SUBJECT: Revised Submittal of Quality Assurance Program for  
Station Operation  
R. E. Ginna Nuclear Power Plant  
Docket Number 50-244

In accordance with 10 CFR 50.54(a)(3), enclosed is Revision 29 to the Quality Assurance Program for Station Operation (QAPSO) for the R.E. Ginna Nuclear Power Plant. Revision 29 incorporates the following changes:

R.E. GINNA NUCLEAR POWER PLANT

FIGURE 17.1.2-1

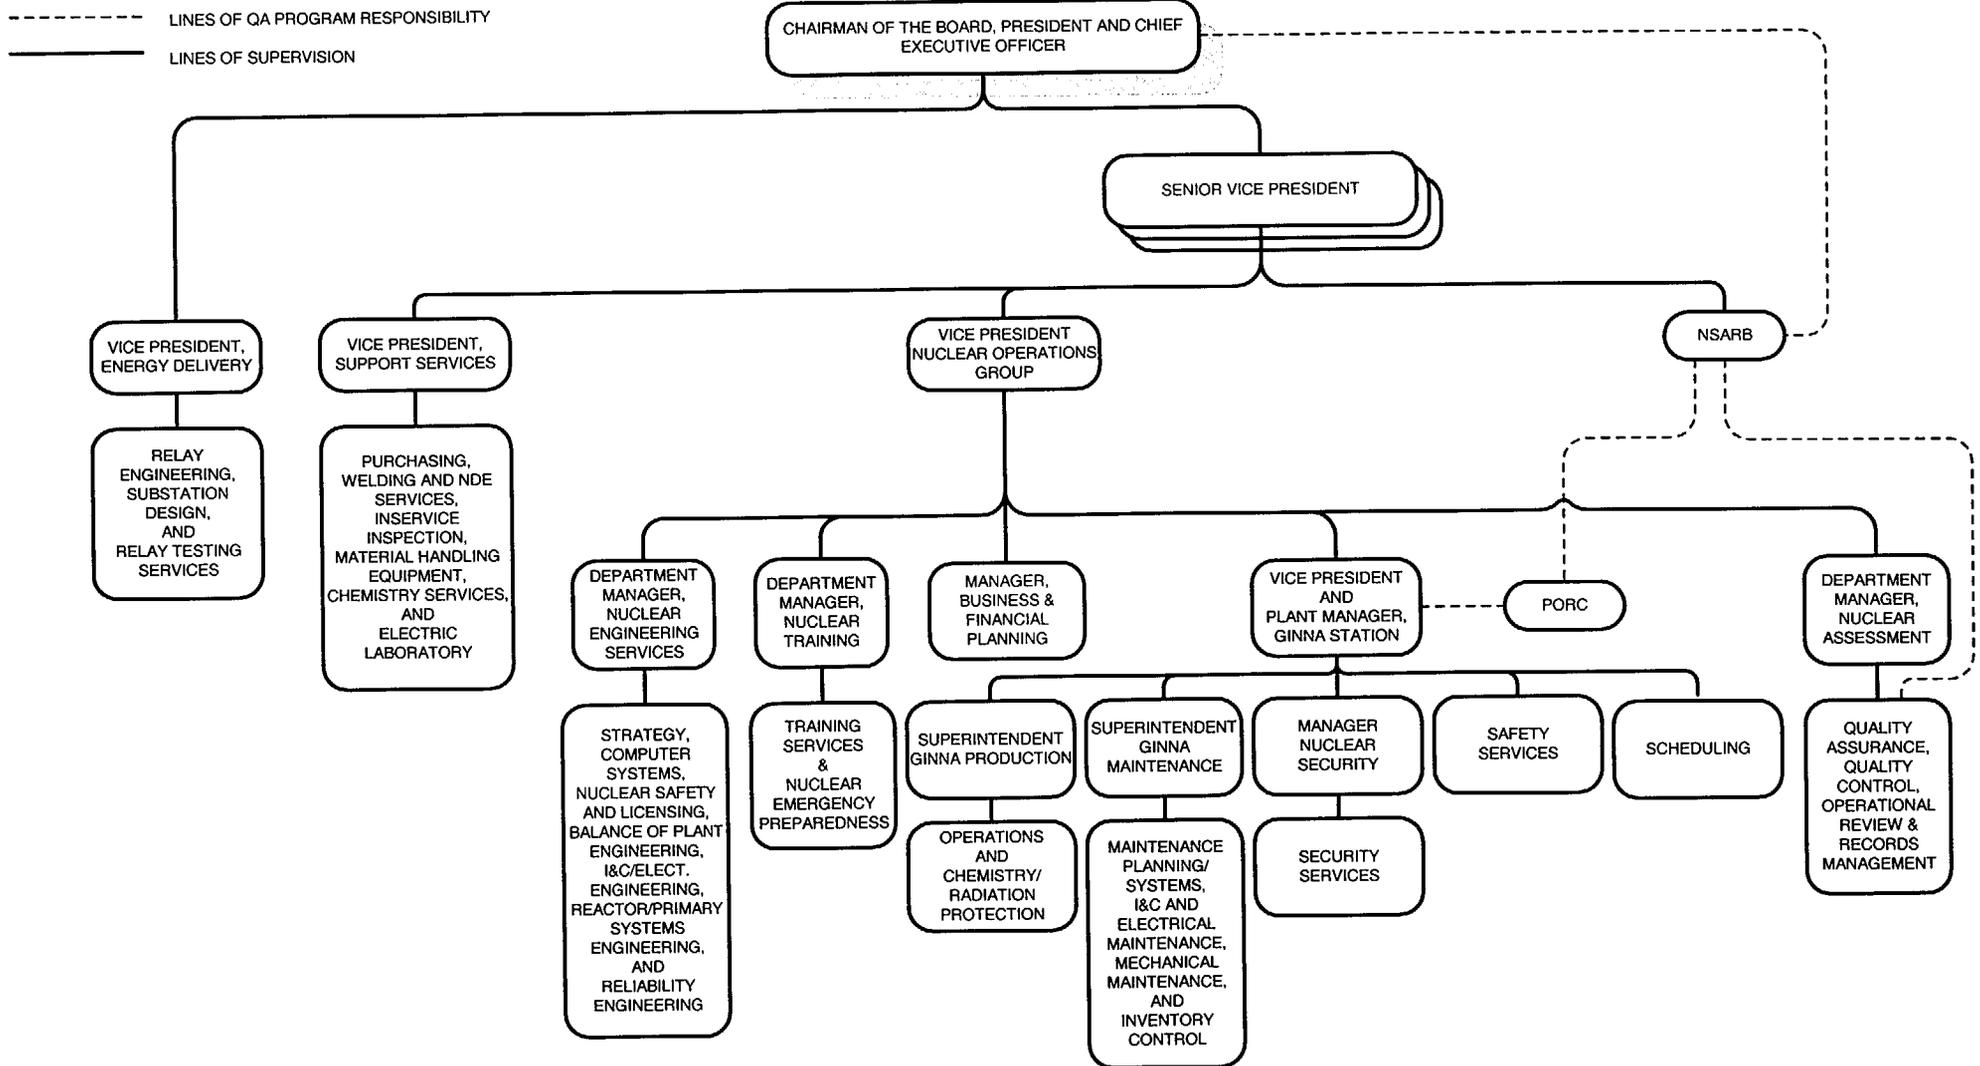
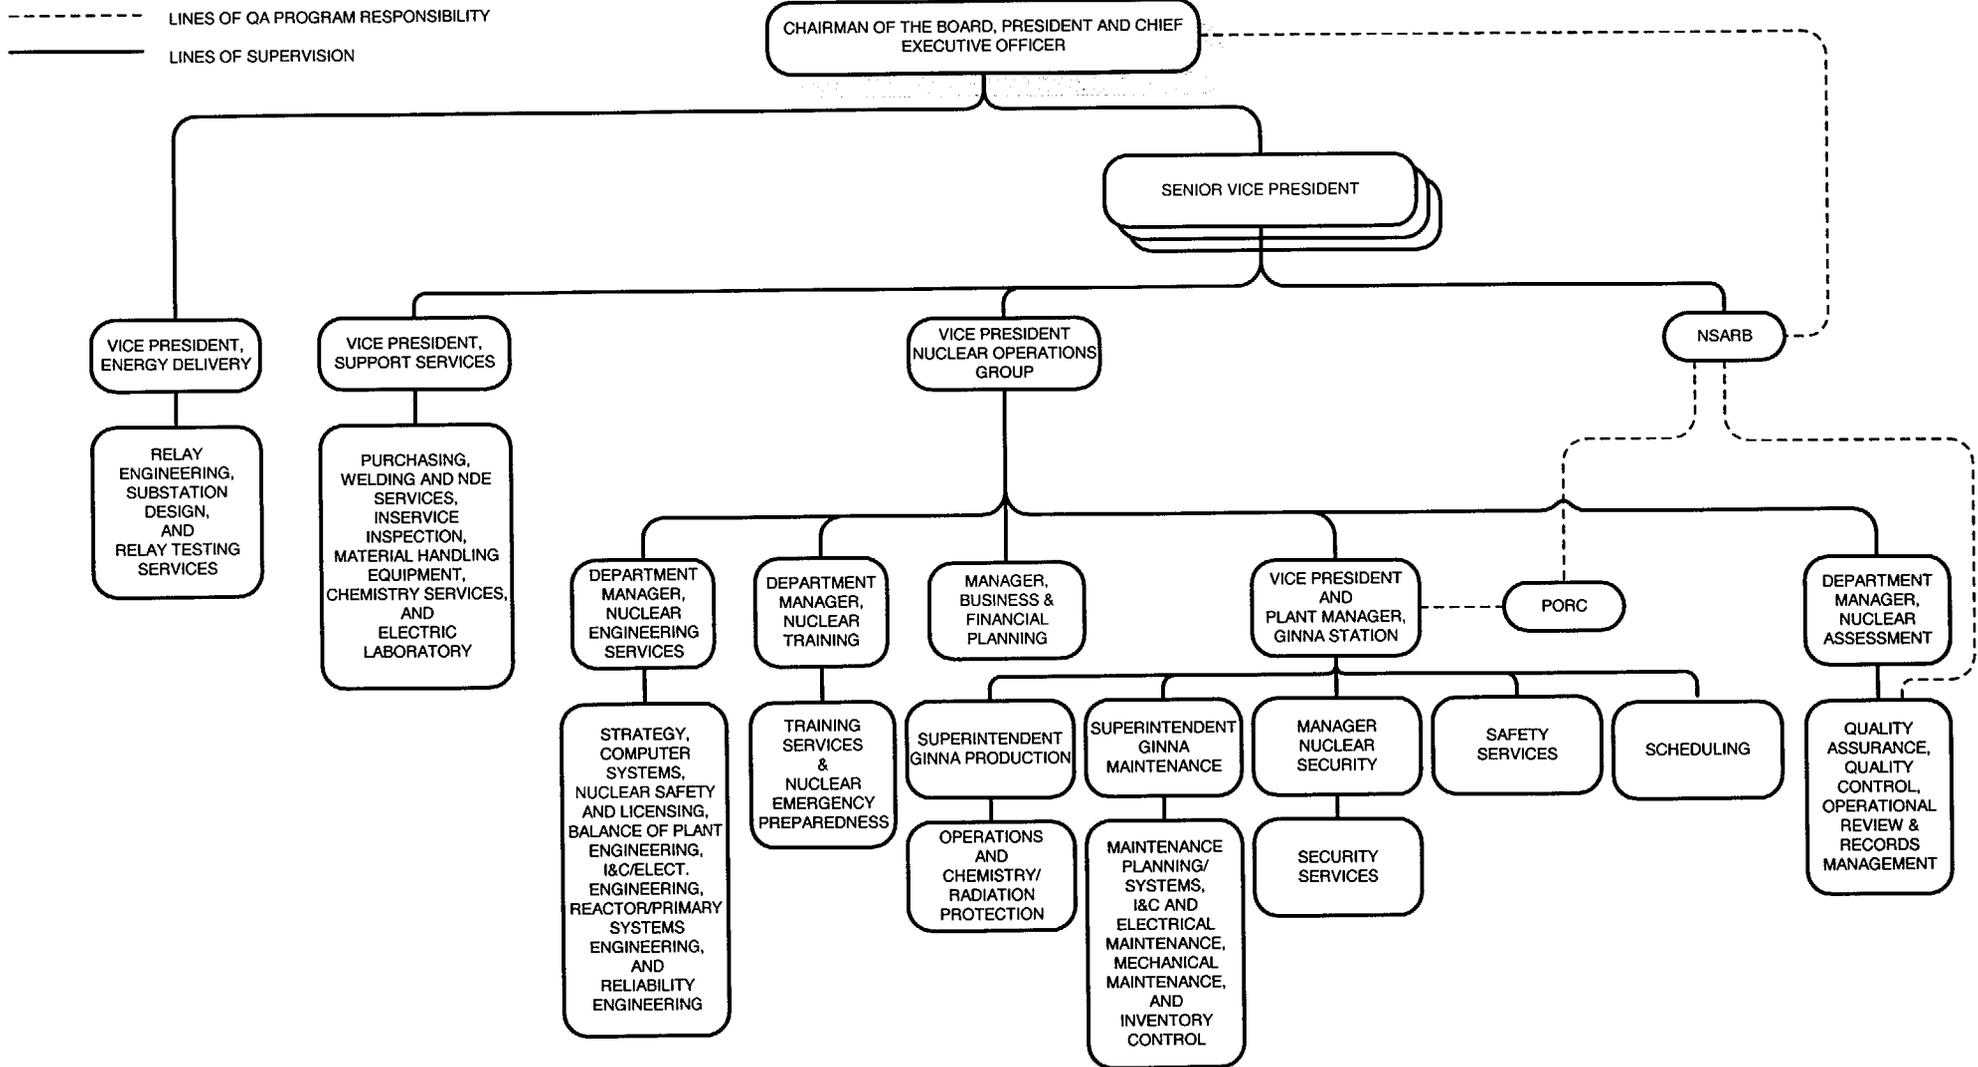
The following organization changes are reflected throughout the text of the document and on the Figure 17.1.2-1 Organization Chart:

1. A reorganization of Nuclear Engineering Services resulted in the elimination of the Configuration Support Section.
2. Changed the title of "Director, Budget and Cost" to "Manager, Business and Financial Planning".
3. Removed the Senior Vice President, Corporate Services from the Ginna organization structure.
4. Revised wording to clarify NSARB responsibility for directing and evaluating internal audits.
5. Changed title of "Senior Vice President, Generation" to "Senior Vice President" and "Supervisor, Nuclear Security" to "Manager, Nuclear Security."
6. The responsibility for review of INPO documents and NRC Information Notices has been transferred from Nuclear Safety & Licensing to Operational Review.
